## DEVELOPMENT APPLICATION ASSESSMENT REPORT

<b>Application Number:</b>	DA2025/0115
----------------------------	-------------

<b>Responsible Officer:</b>	Olivia Ramage
<b>Land to be developed (Address):</b>	Lot 371 DP 531048, 77 Bungan Head Road NEWPORT NSW 2106
<b>Proposed Development:</b>	Alterations and additions to a dwelling house
<b>Zoning:</b>	C4 Environmental Living
<b>Development Permissible:</b>	Yes
<b>Existing Use Rights:</b>	No
<b>Consent Authority:</b>	Northern Beaches Council
<b>Land and Environment Court Action:</b>	No
<b>Applicant:</b>	William Fleming

**Figure 1 - Established building line plan provided by Karen Buckingham in submission**

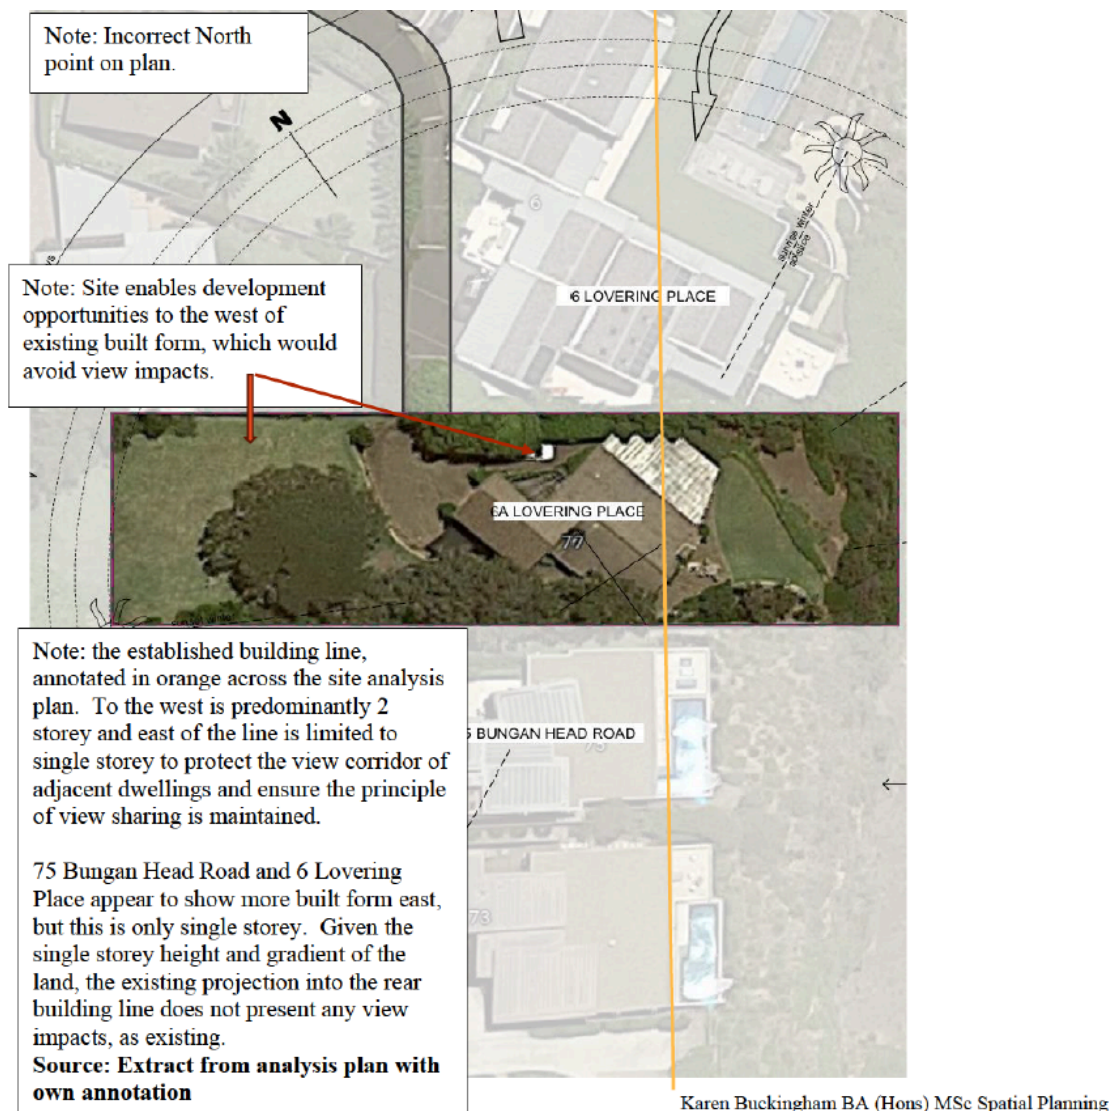
*The submissions state that adjoining properties demonstrate a consistent building line where architectural designed homes include only single storey built form, pools or decks beyond an established line as shown in Figure 1 below. The submission states that maintaining this established line as single storey preserves amenity and enables view sharing. Concern is raised that the proposal provides a second storey contrary to this established building line which causes view loss impacts.*

The established building line referred to above in the submissions is not enforced by a control or clause in any EPI applicable to the site, rather relates to mere characteristics of the environment. As such, it is not reasonable to restrict development that otherwise complies with all the relevant planning controls.

Figure 18 - Site plan showing extent of spatial separation

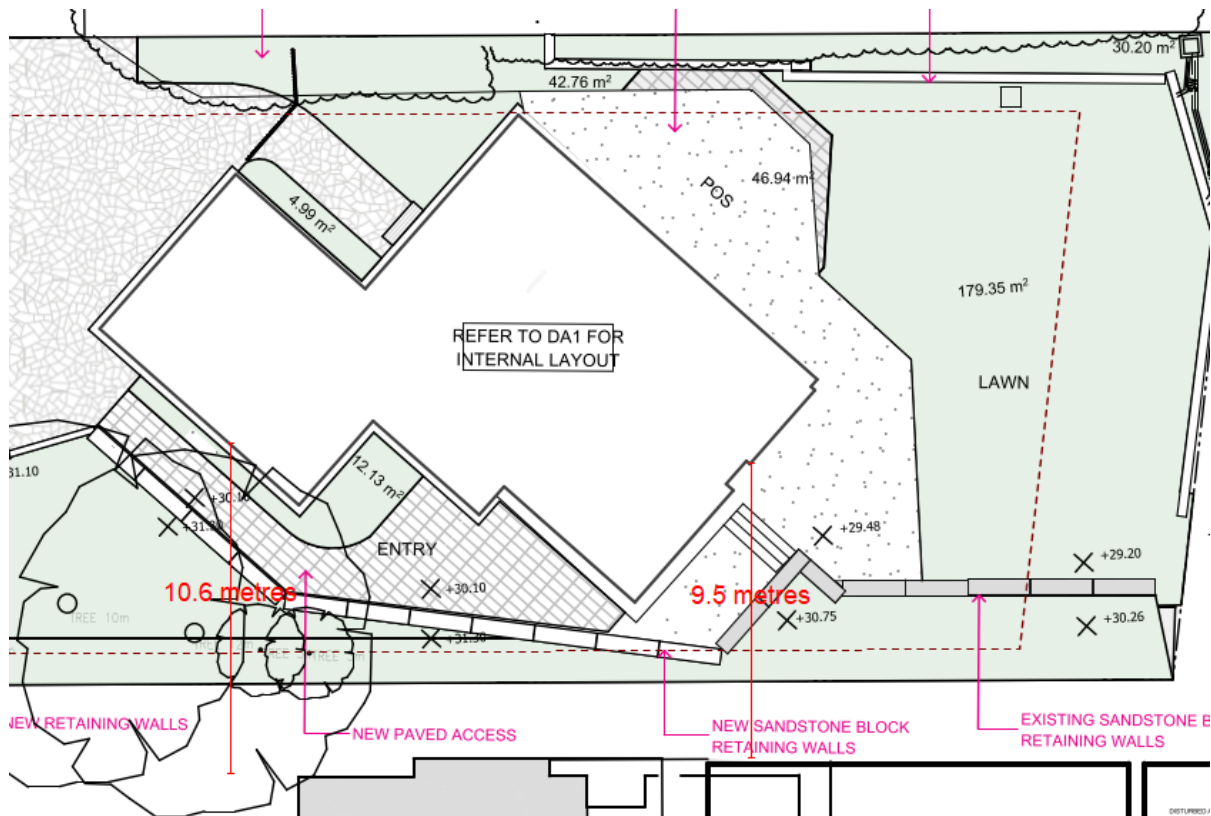
The proposed first floor contains windows W14 and W15 to the ensuite and W16 to the walk-in-robe which are all louvred windows. Given the nature of these rooms, the louvres are likely to be shut when occupied and therefore will not give rise to unreasonable privacy impacts. Additionally, the existing dwelling on the subject site is slightly angled and orientated to the north-west. As a result, the windows are offset from the side boundaries and do not directly face the adjoining dwelling at 75 Bungan Head Road. Similarly, windows W11, W12, W13a and W13b are orientated to the eastern rear of the site towards the ocean views. Additionally, the larger picture windows are further to the north providing more than 9.0m of spatial separation to the living room and private open space at 75 Bungan Head Road as shown below. Similarly, the windows on the southern side are to the sewing/study room and two bedrooms which are also offset from the side boundaries. As shown below, more than 9.0m of spatial separation is provided to the terrace courtyard, thereby protecting private open space areas. Lastly, the first floor level sits at RL 32.79 and RL 33.24 and 75 Bungan Head Road sits at RL 35.25 at the living room and RL 35.15 at the balcony and courtyard. As such, there is a level difference between the floor levels of the properties which further mitigates overlooking.

Figure 21 - North elevation showing envelope encroachments in red

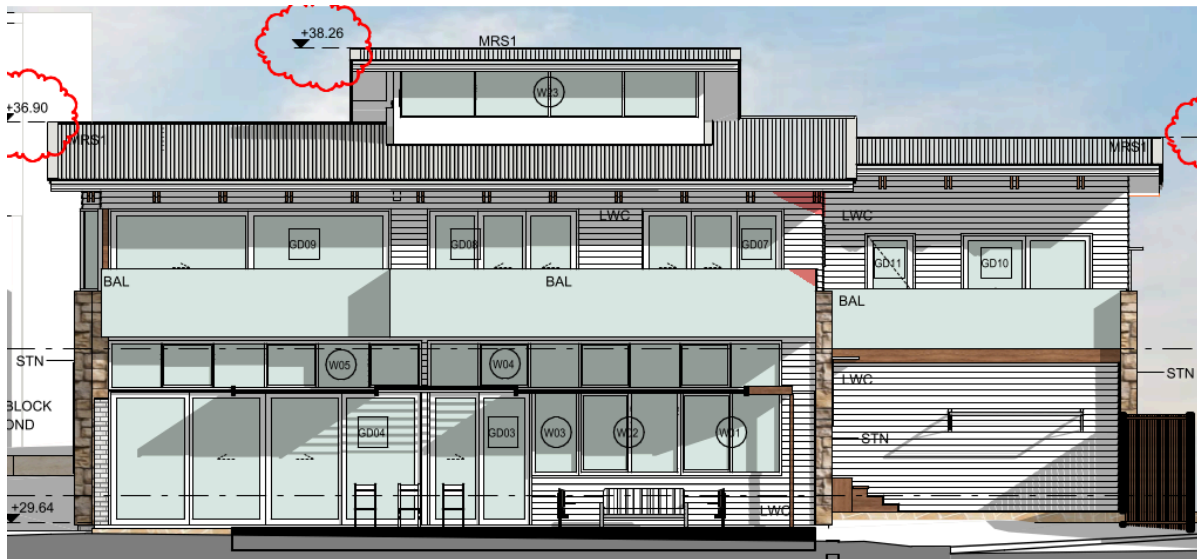
The proposed development encroaches the northern side building envelope to a minor extent at 2 areas as shown below:
